## Product change information (PCN)

PCN No.:	ABG170006	Date:	10.05.2017
----------	-----------	-------	------------

Order No.	Designation
	WML... (see list)

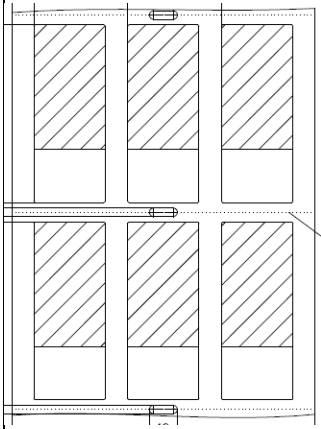
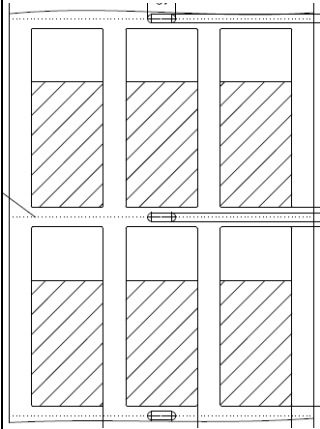
### Material arrangement changed by 180 ° and color code

The layout of the labels on the roll is rotated by 180 ° so that the label with the transparent side first comes out of the printer. At the same time the color system is adjusted. The white and yellow is then equivalent to the color system to the production stand V / C 05.

The description changes with the addition "WML ... \_180". Our e-shop and the CLIP PROJECT marking software are adapted from KW 14 onwards. This is an adaptation of print quality and handling. All other technical parameters remain.

Previous production status	New production status
 <p>alt V/C (06 und 04) Material description: "WML ..."</p>	 <p>neu V/C (07 und 05) Material description: "WML ..._180"</p>
